CITY OF UNLEY

COUNCIL ASSESSMENT PANEL

21 December 2021

| 1. | 4 Leah Street Forestville – 21003112 | 4-192 |

Image K – Facing south-west (with proposed building)

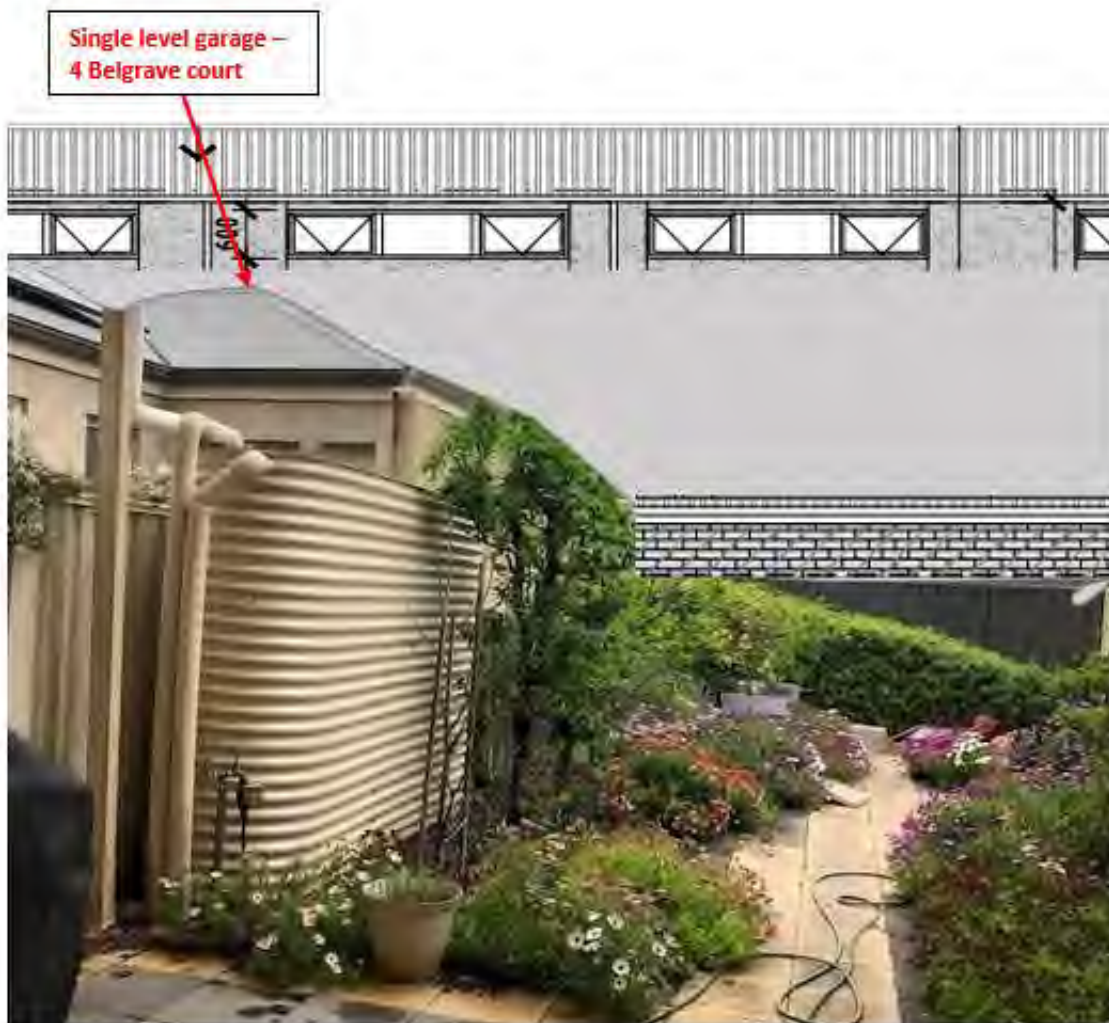
A built form that provides a transition down in scale and intensity at the zone boundary to maintain the amenity of residential properties located within adjoining zones.

Image L – Shadow plan with actual shading impact

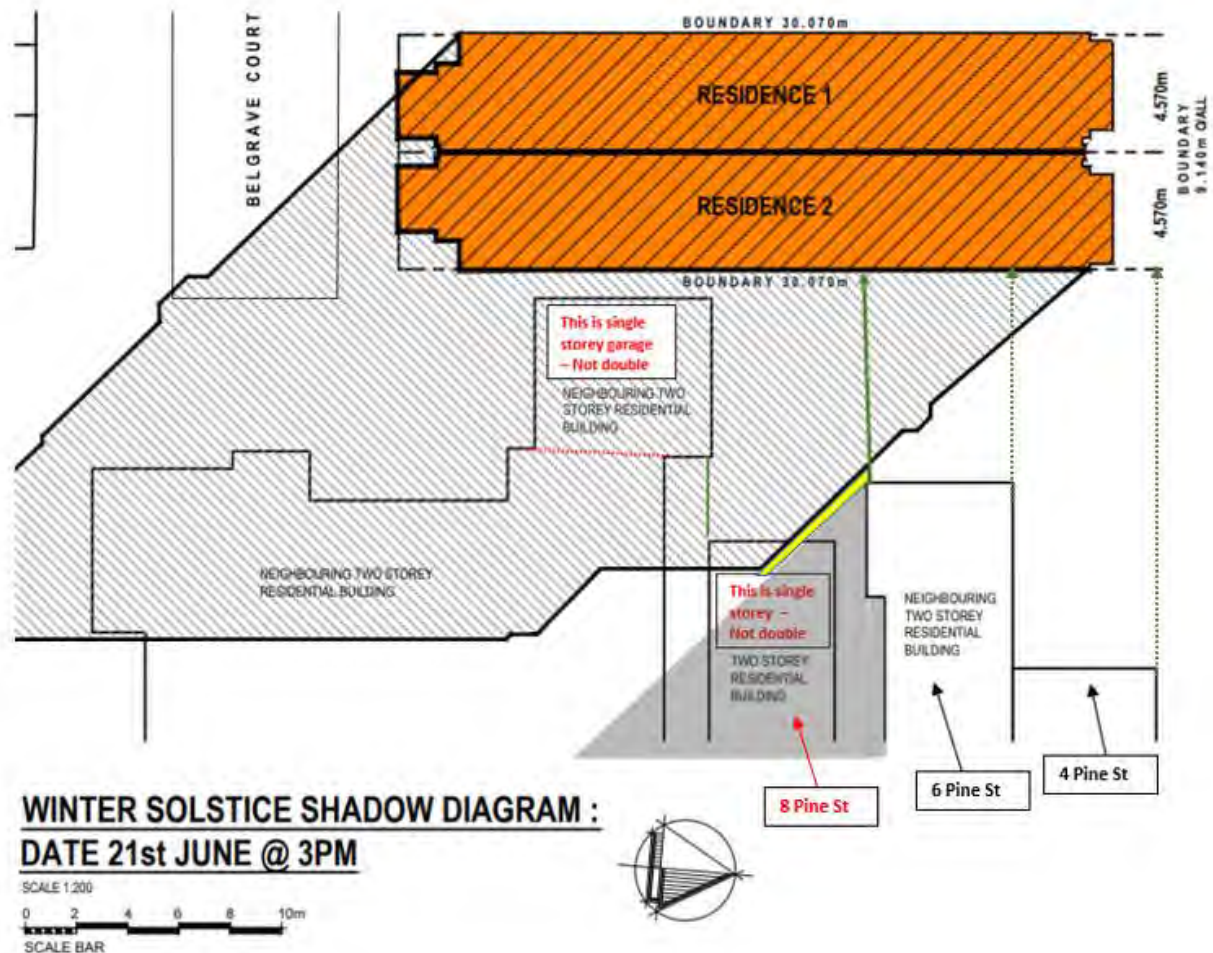
When all the overshadowing is taken into account, our only living areas and outdoor area are totally overshadowed, except for the tiny sliver between the two grey shaded areas (see yellow highlighted area in Image L).
